Product / Process Change Notification (PCN)	
<input type="checkbox"/> Major Change <input checked="" type="checkbox"/> Minor Change	
PCN Number: PCN_SwTATL_20240925 Affected Series: WS-TATL Affected Order Codes: 440GS67082622, 440BS67082622, 440VR67082622, 440RS67082622, 440YS67082622 PCN Date: 2024-06-25 (YYYY-MM-DD) Effective Date: 2024-09-25 (YYYY-MM-DD)	Change Category: <input type="checkbox"/> Equipment/Location <input checked="" type="checkbox"/> General Data <input type="checkbox"/> Material <input type="checkbox"/> Process <input type="checkbox"/> Product Design <input type="checkbox"/> Shipping/Packaging <input type="checkbox"/> Supplier <input type="checkbox"/> Software
Contact: Product Management Phone: +49 (0) 7942 - 945 5001 Fax: +49 (0) 7942 - 945 5179 E-Mail: pcn.eican@we-online.com	Datasheet Change: <input checked="" type="checkbox"/> Yes <input type="checkbox"/> No Attachment: <input type="checkbox"/> Yes <input checked="" type="checkbox"/> No

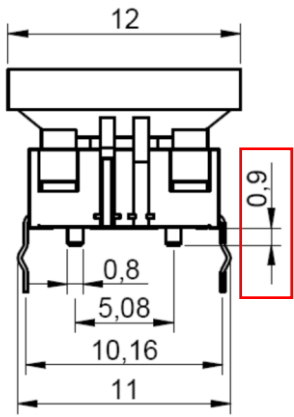
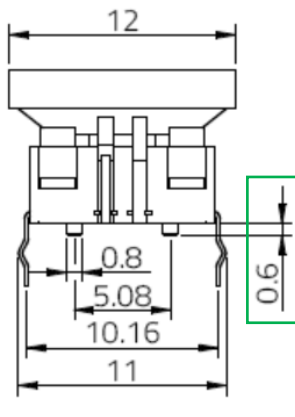
Description of Change: As a datasheet information correction, Würth Elektronik eiSos will correct the drawing dimension of positioning hole in the datasheet. This is a datasheet correction only. There will be no change in form, fit, function, quality or reliability of the product.	
Details of Change:	
Before Change The original drawing had a wrong height. 	After Change The correction consist on the modification of the height. 
Reliability / Qualification of Change: There will be no change of the product, therefore no additional reliability or qualification testing was performed.
